**Lee Nuclear Station Units 1 and 2
Description, Scope of Changes, and FSAR Impacts due to Plant Relocation and
Additional Design Enhancements**

**Description and Rationale for Lee Nuclear Station Units 1 and 2 Relocation and
Additional Design Enhancements**

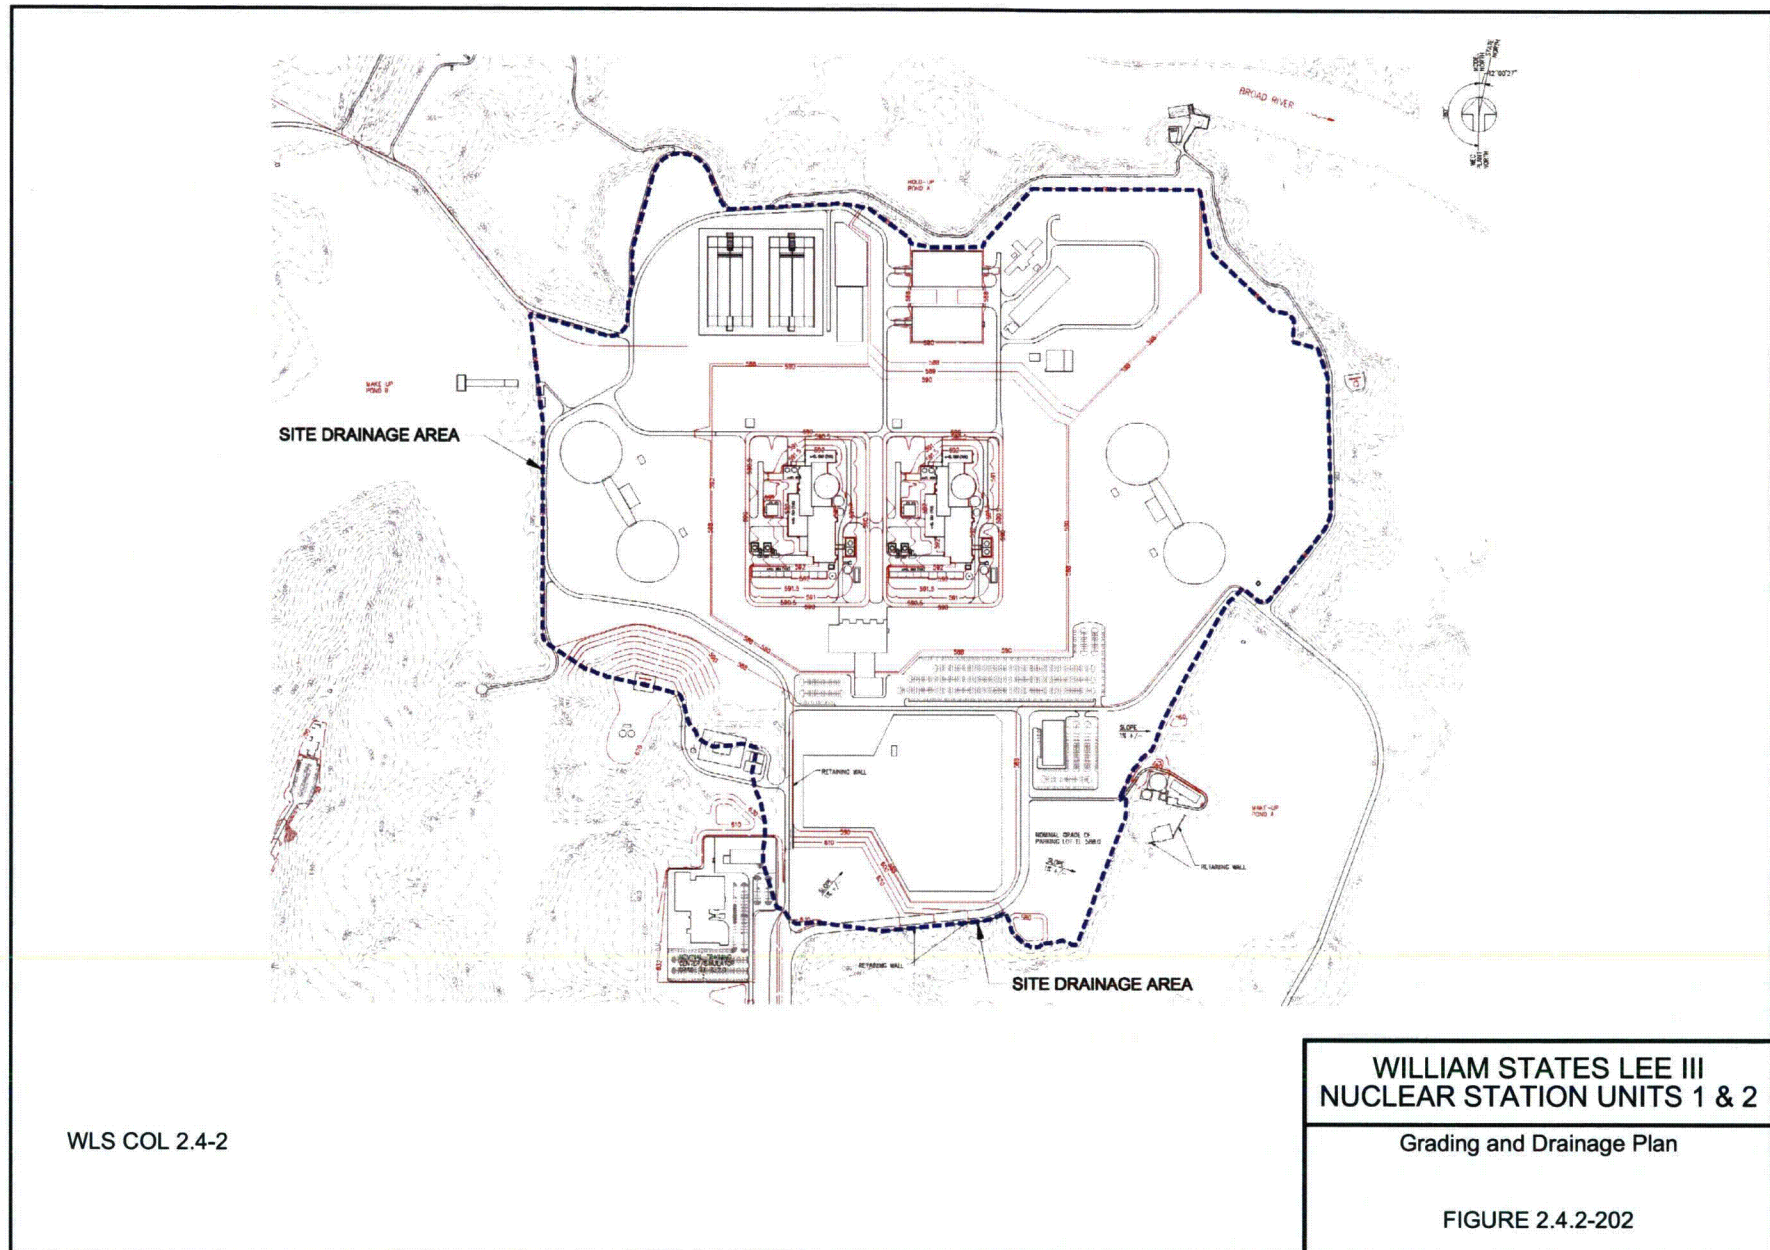
43. COLA Part 2, FSAR Chapter 2, Figure 2.4.1-214 is revised as follows:

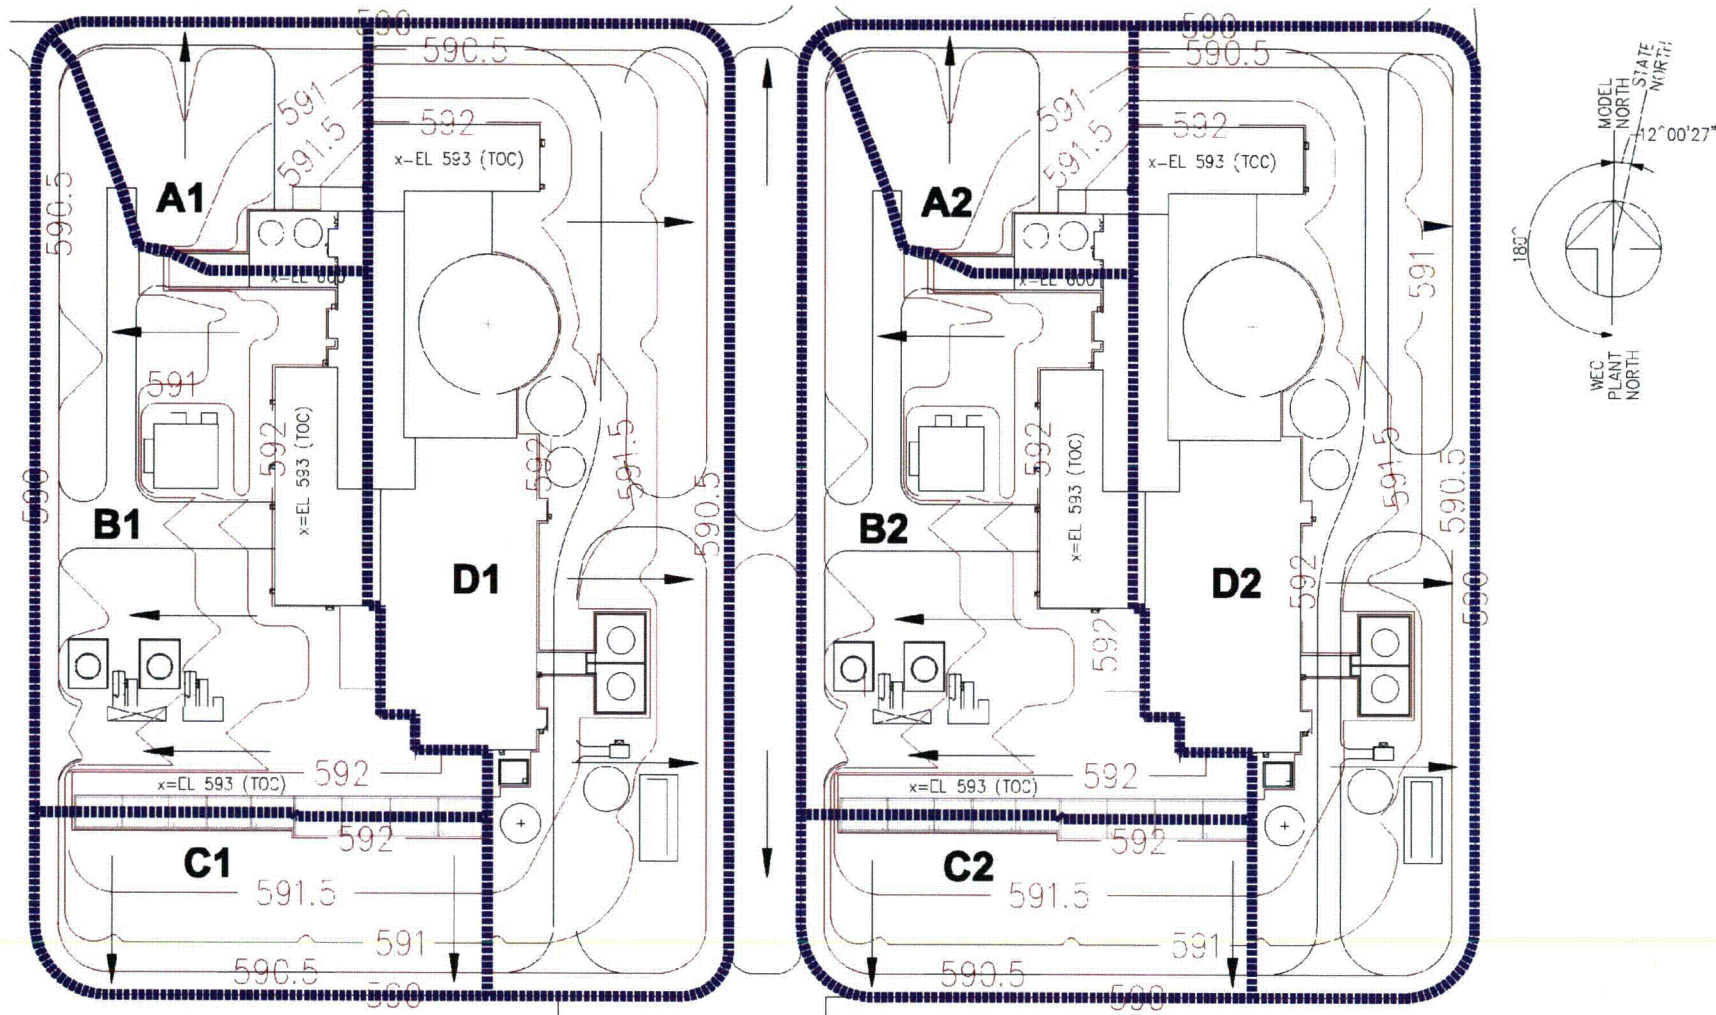
~~Portions of the site are relatively flat; however~~ The site is generally defined by wide flat areas. ~~However,~~ the site is graded such that runoff will drain away from safety-related structures either to Make-Up Pond B, Make-Up Pond A, or directly to the Broad River ~~through five grass covered drainage channels. These channels, illustrated in Figure 2.4.2-202, are assumed to be the only flow paths for runoff from the site and establish the downstream boundary conditions for site runoff for modeling purposes.~~ Runoff from a specific power block area flows through four graded channels per unit as described in the discussion below and then ~~through the five site discharge channels~~ flows across the site to the receiving water body. Computed water surface elevations in the vicinity of safety-related structures are below plant elevation ~~590-593~~ 593 ft. The site grading and drainage plan is shown in Figure 2.4.2-202.

44. COLA Part 2, FSAR Chapter 2, Figure 2.4.2-202 is revised as follows:

FIGURE 2.4.3-201

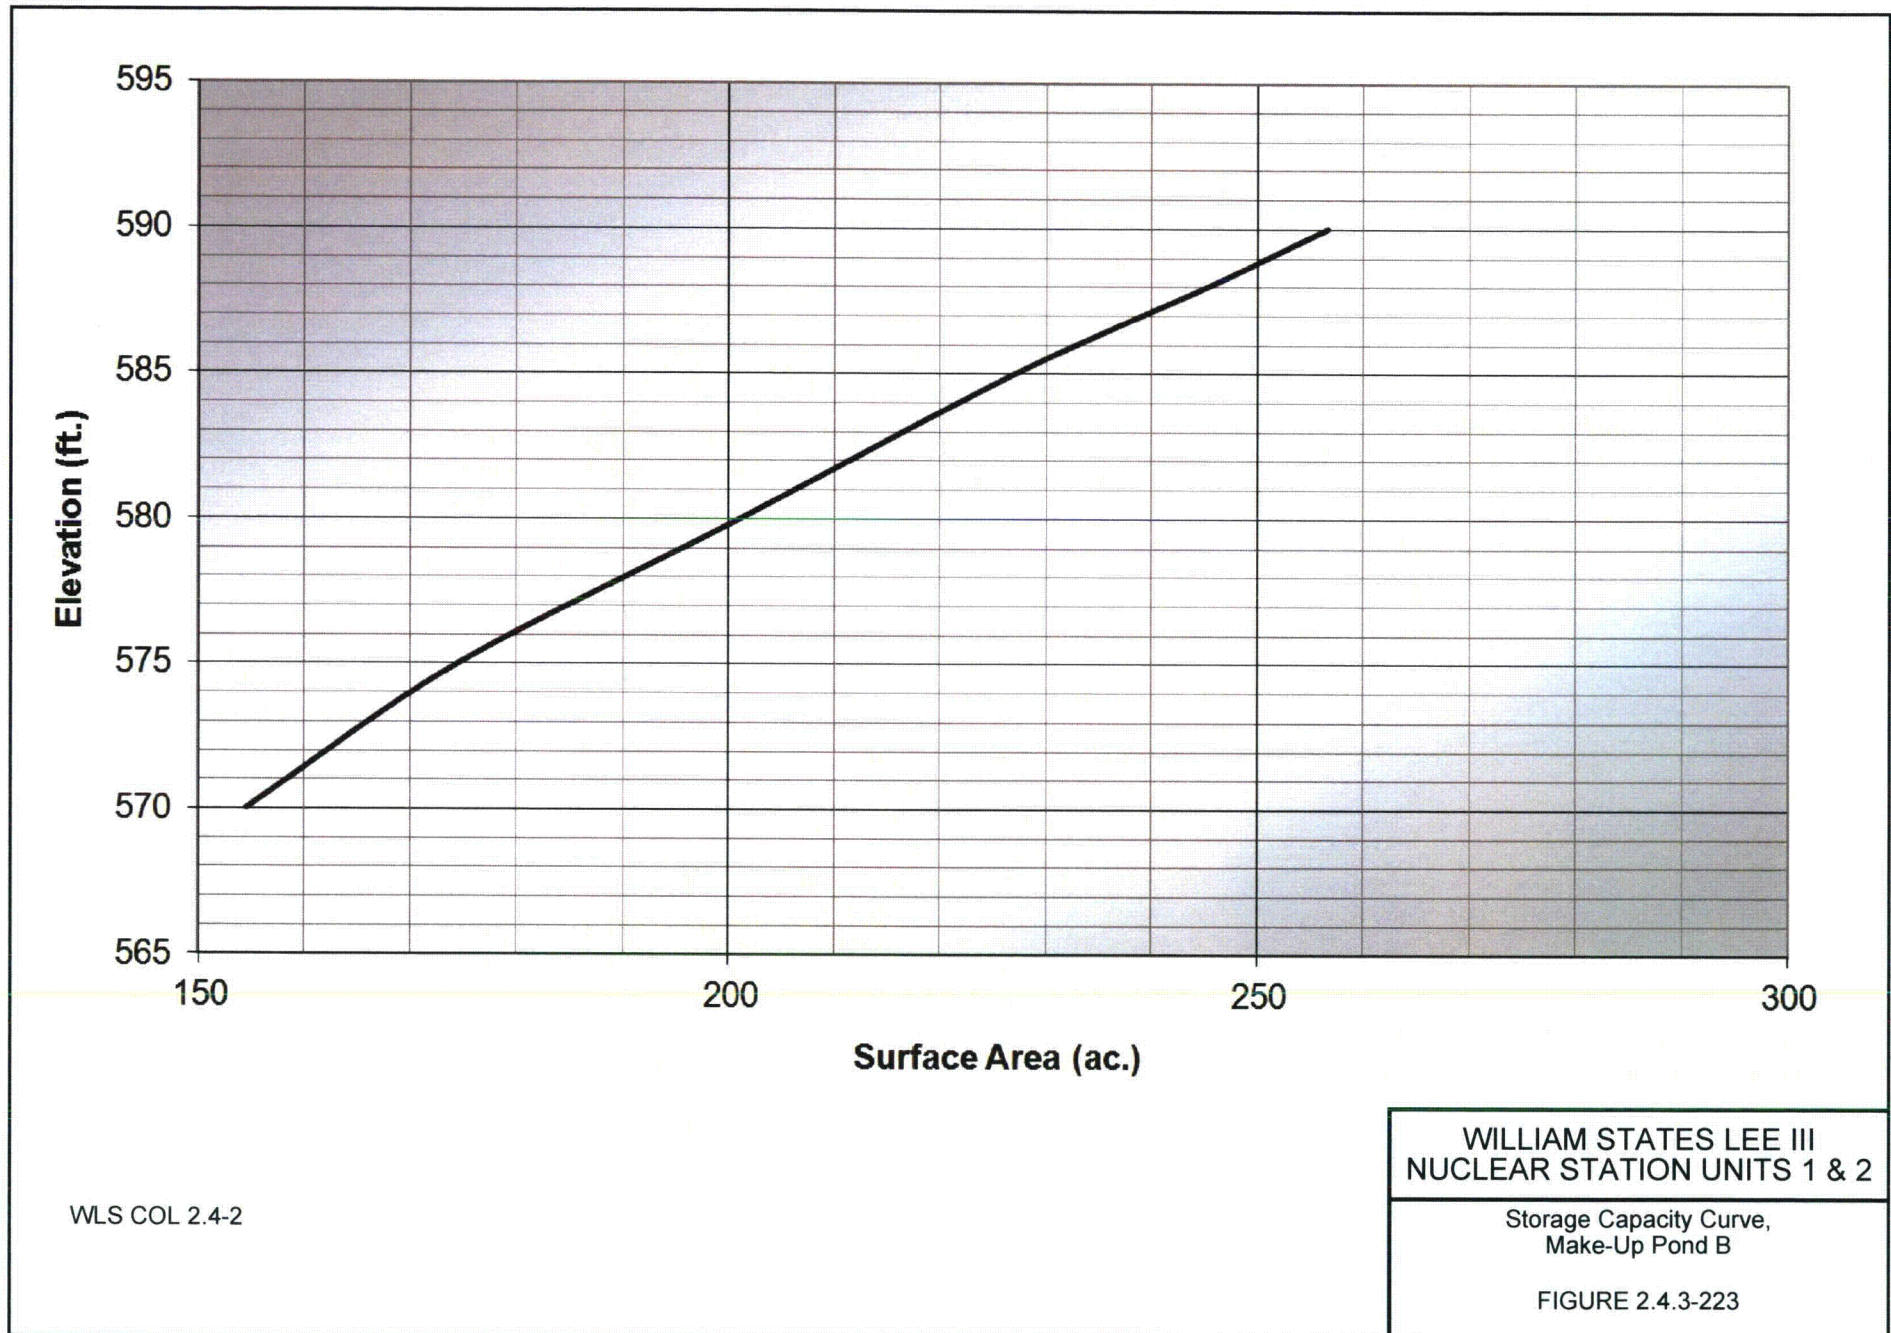
46. COLA Part 2, FSAR Chapter 2, Figure 2.4.3-201 is revised as follows:

FIGURE 2.4.3-225

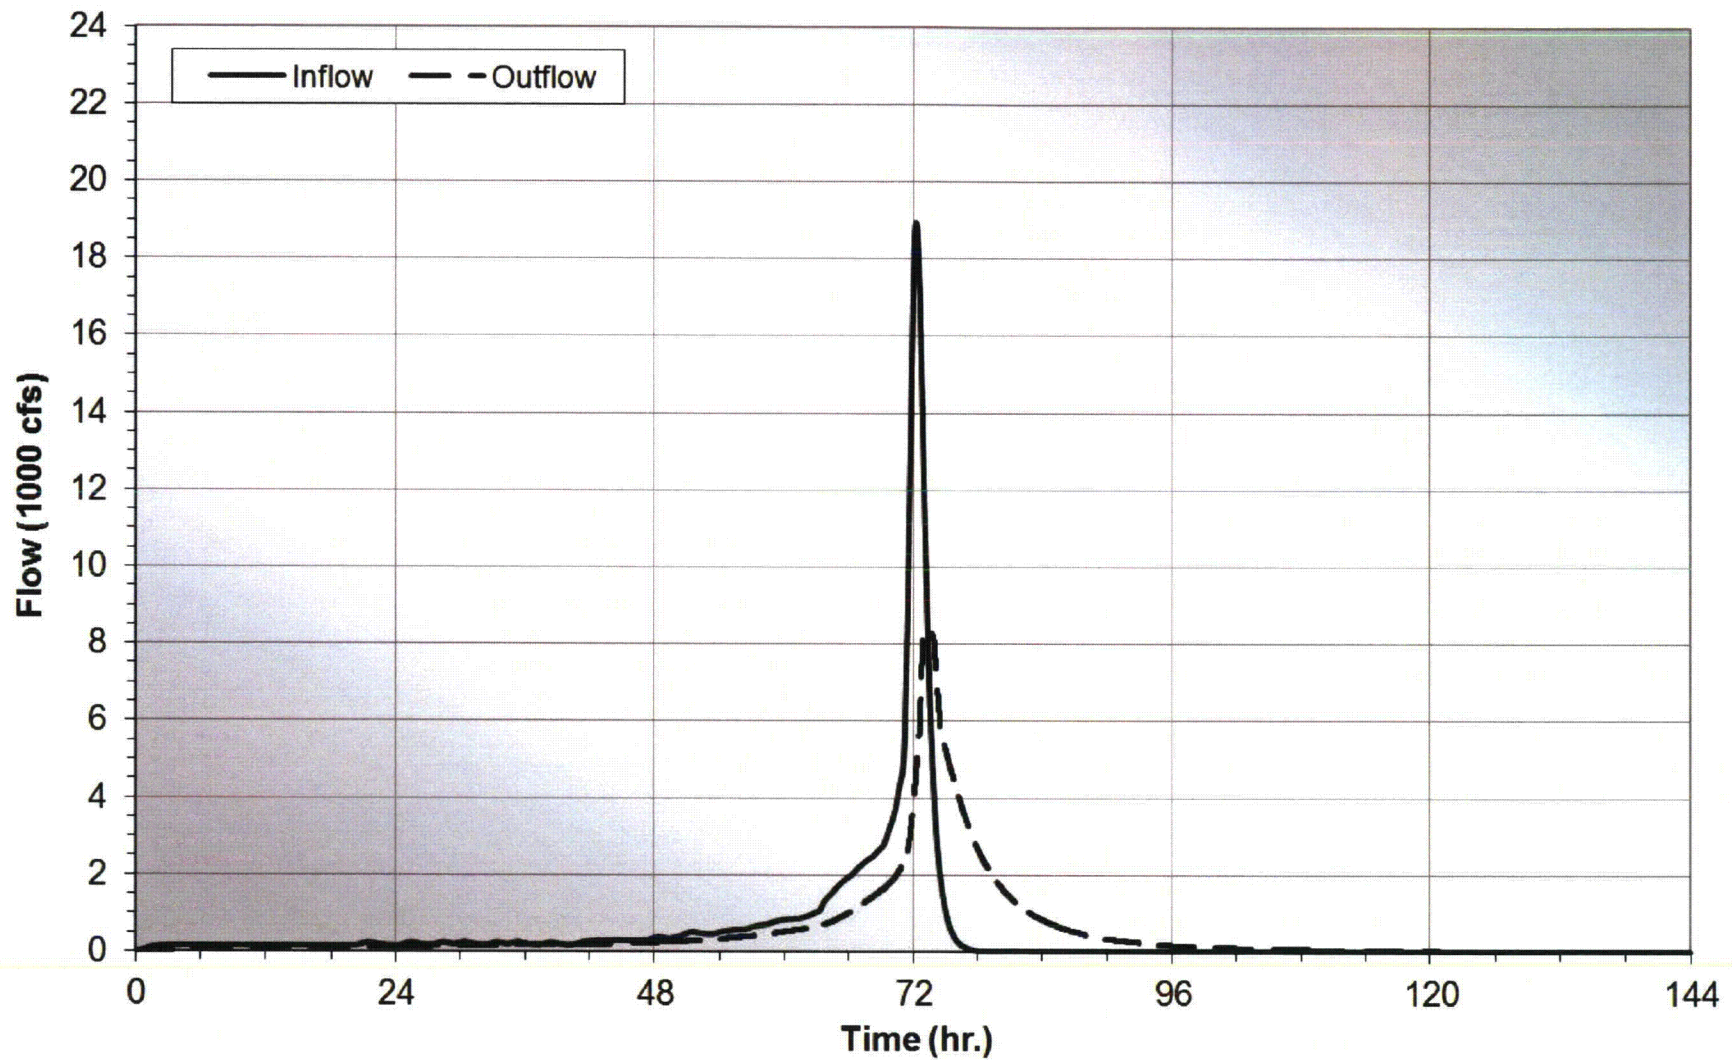
48. COLA Part 2, FSAR Chapter 2, Figure 2.4.3-225 is revised as follows:

FIGURE 2.4.3-227

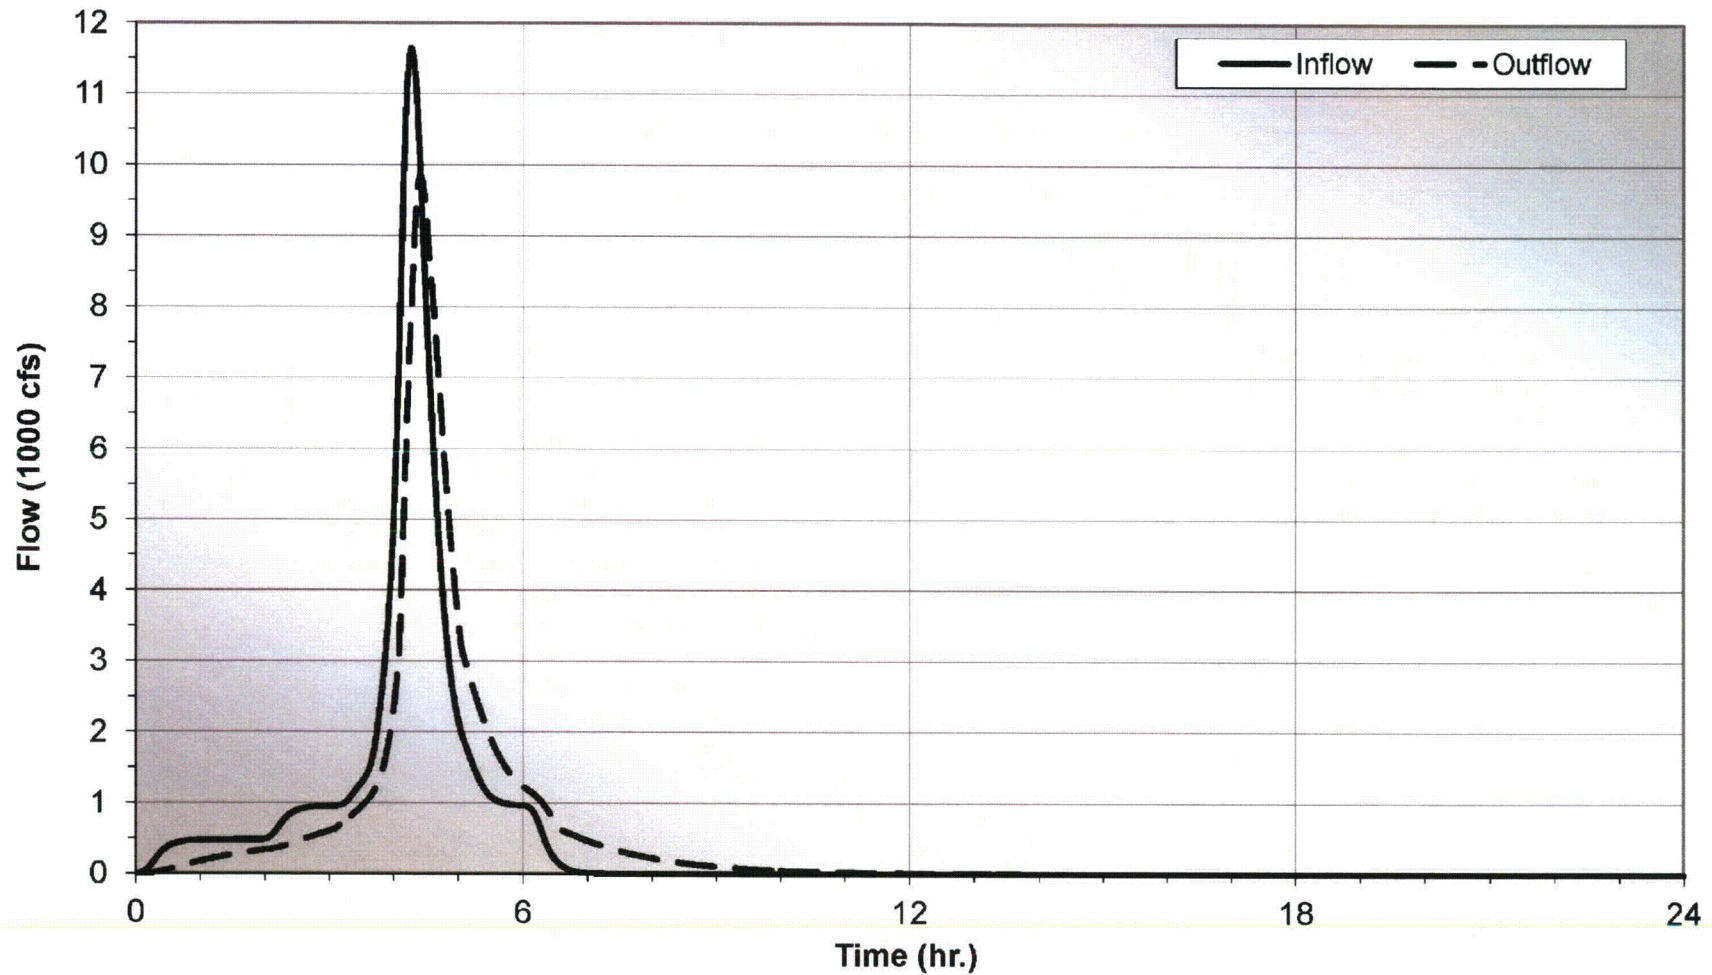
However, the 72-hr. tail end peaking storm event resulting in a peak PMF runoff of ~~18,813~~18,937 cfs and a routed discharge of ~~8249~~8386 cfs provided the controlling water surface elevation. The peak runoff in the Upper Arm Dam during the 72-hr. tail end peaking storm event will be ~~3446~~3577 cfs with a peak discharge of ~~3381~~3549 cfs. The resulting Make-Up Pond B flow hydrograph for the 72-hr. tail end peaking storm event is shown in Figure 2.4.3-227. Temporal distribution of the PMP is discussed in Subsection 2.4.3.1.

49. COLA Part 2, FSAR Chapter 2, Figure 2.4.3-227 is revised as follows:
